Docket Number:	14-AAER-02
Project Title:	Computer, Computer Monitors, and Electronic Displays
TN #:	206070
Document Title:	ITI & Technet Comments: Re CEC Energy Savings Modeling Issues
Description:	N/A
Filer:	System
Organization:	Chris Hankin, for ITI & Technet
Submitter Role:	Public
Submission Date:	9/11/2015 12:42:06 PM
Docketed Date:	9/11/2015

CEC Draft Computer Standards (Docket #14-AAER-2)

ITI/TechNet Comments on CEC Energy Savings Modeling Issues

Date: September 11, 2015

Figure 1

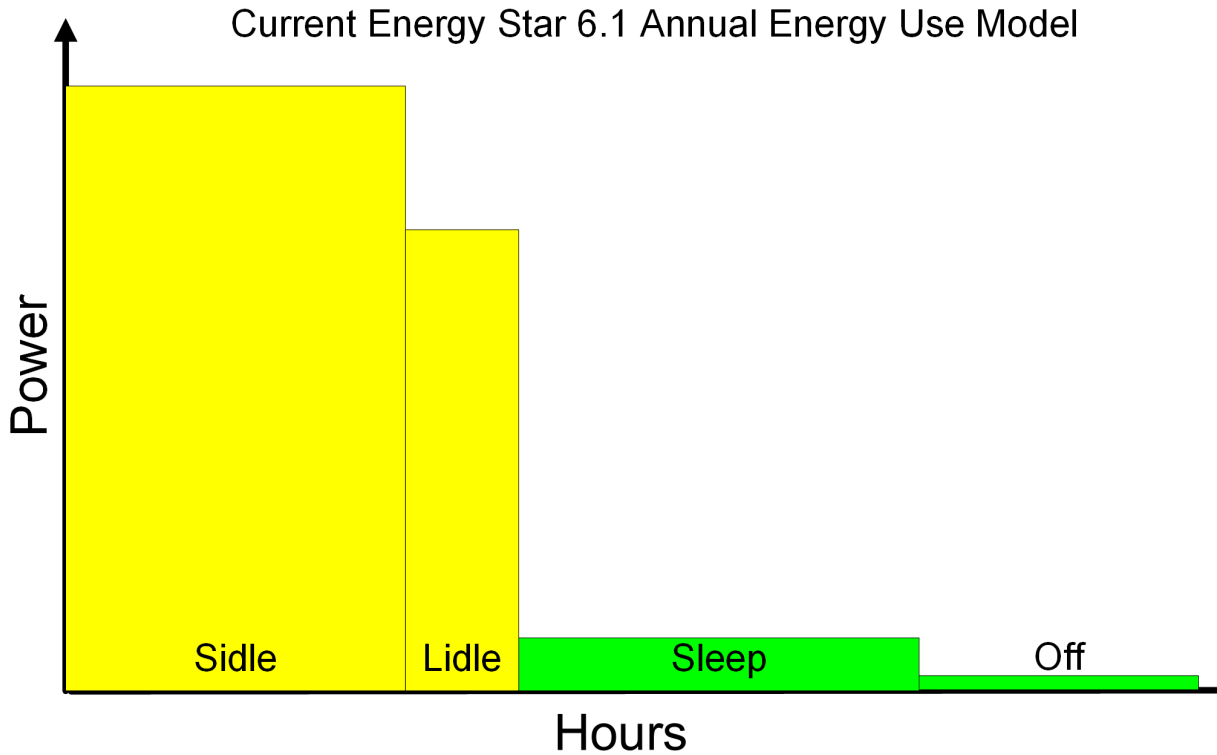
Figure 1 is a visual representation of the relative magnitude of power levels and time in operating modes for an average category 0 desk top computer from the Energy Star qualified products list as of July 27, 2015.

Average power for each operating mode was calculated by averaging the power values for that mode in the Energy Star qualified products data base for Category 0 desk top computers.

Figure 2

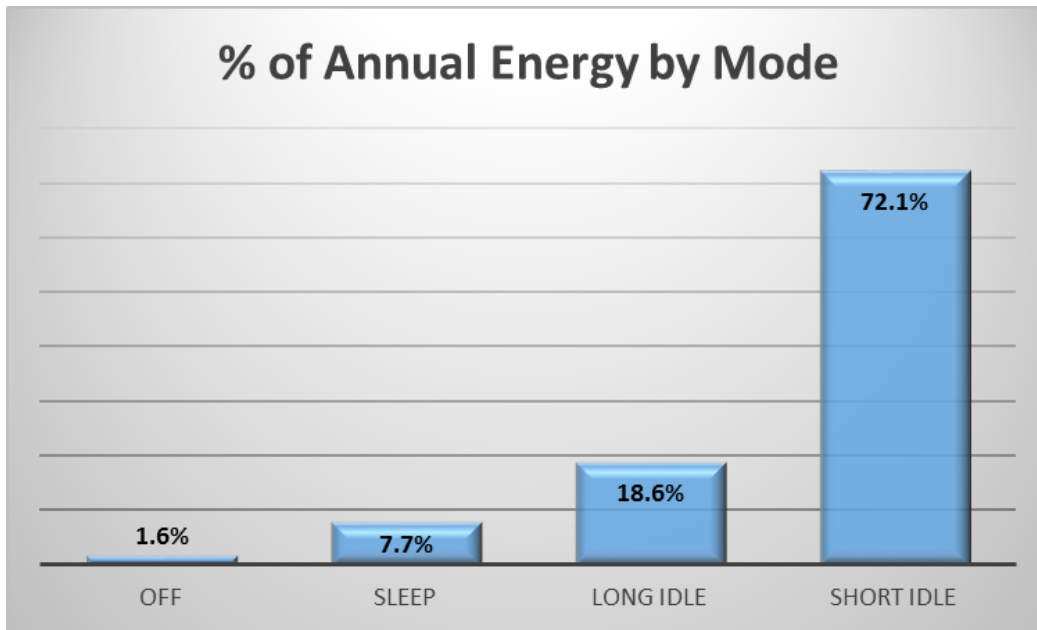
Figure 2 shows the percentage of annual energy consumed in each operating mode using the average power values for Category 0 from above in Equation 1 using mode weightings from Table 1.

Using this methodology a typical Category 0 computer will have 72% of its annual energy consumption derived from short idle power mode and 18.6 percent of its annual energy consumption derived from the Long Idle mode. The average power levels in these two modes will account for 90.6% of the total annual energy consumption using this model. This indicates that reduction of both long and short idle should be focus areas for reducing energy consumption in PC systems and actually have been useful as drivers of energy reduction by the PC industry for many years. Idle power has been a useful proxy for active power since the active power for most end users is not significantly higher than the idle power for the systems in existence today the way they are typically used. The other factor allowing idle power to be a fairly good proxy is the fact that the system improvements made over time that reduced idle power also contributed to reducing the active power. Thus as idle power levels have come down the active power levels and the resulting real world energy usage of PCs have also come down.

Figure 3

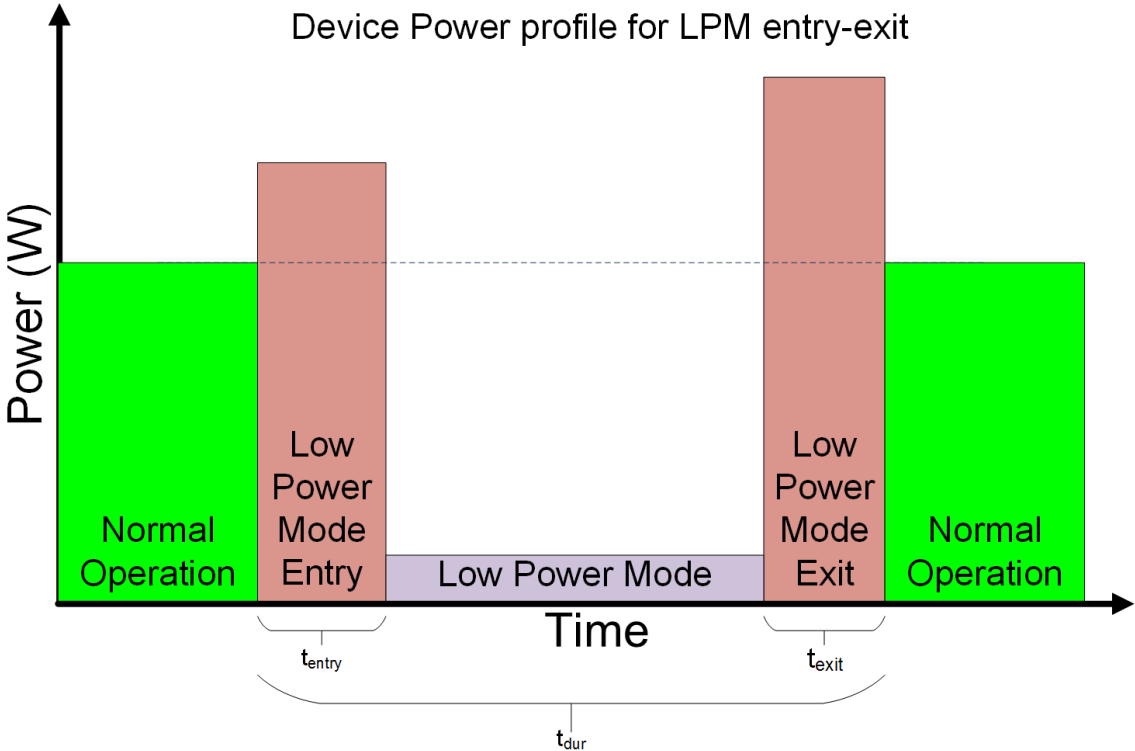
Figure 3 shows an example profile of a device transitioning into and out of a low power state including both entry and exit events and power levels. This diagram shows both entry and exit power levels to be above the active power levels as it is quite typical for devices to require additional activity levels and energy consumption to perform the entry and exit from low power state procedures.

Figure 4

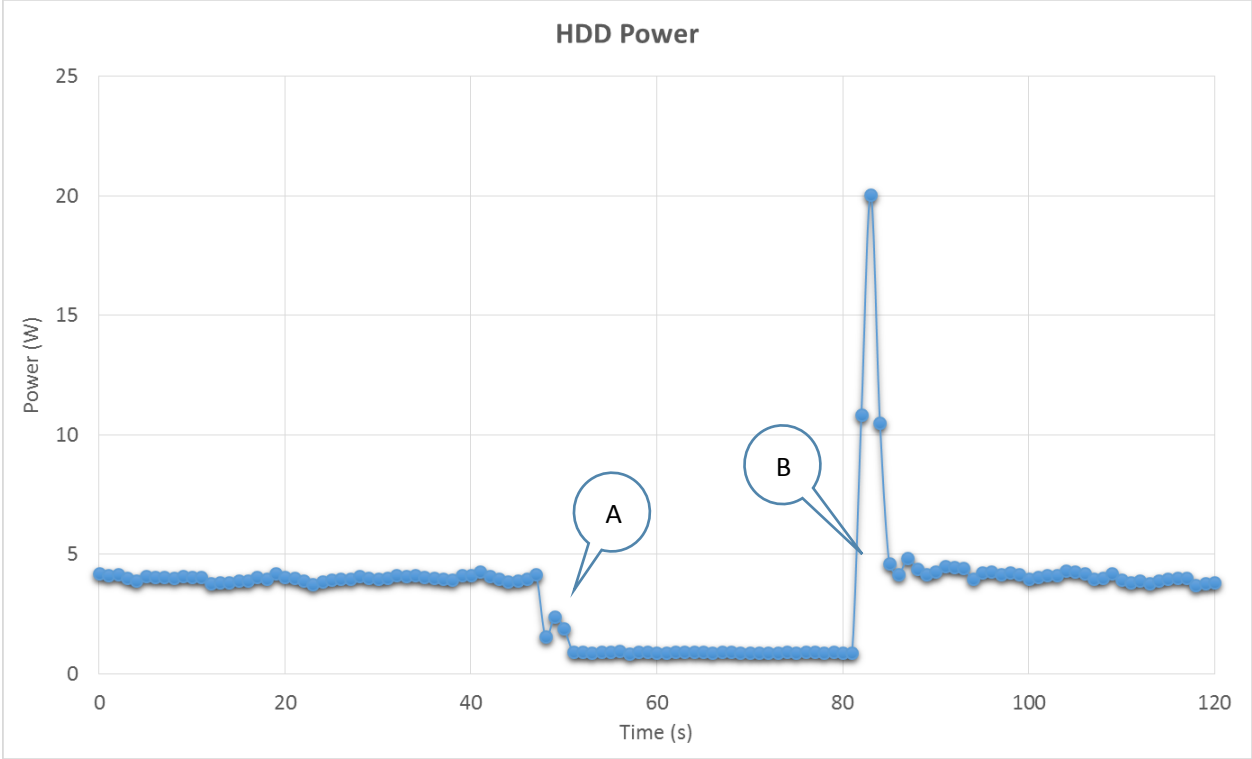
Figure 4 below shows the total power for a HDD during active operation, spinning down the platters, residing on low power state and then resuming to normal operation. HDD's have a peculiar profile as the power level during entry is lower than the active power primarily due to the recovery of the energy in the platters as they are spun down. The reverse is true on low power mode exit where a very large power level is required to spin the platters back up. These two transitions can be seen as items A and B

in the figure. The graph has a sample rate of one sample per second and it can be seen near callout A that it takes at least 4 seconds to transition from active to low power state for the HDD and between 4 and seven seconds minimum to transition between the low power state and the active state as be seen at callout B. The other item of note for a hard drive recovery process is that the power level rises to about 4X the active power level in order to restore the HDD to the active state from the low power state with the platters spun down.
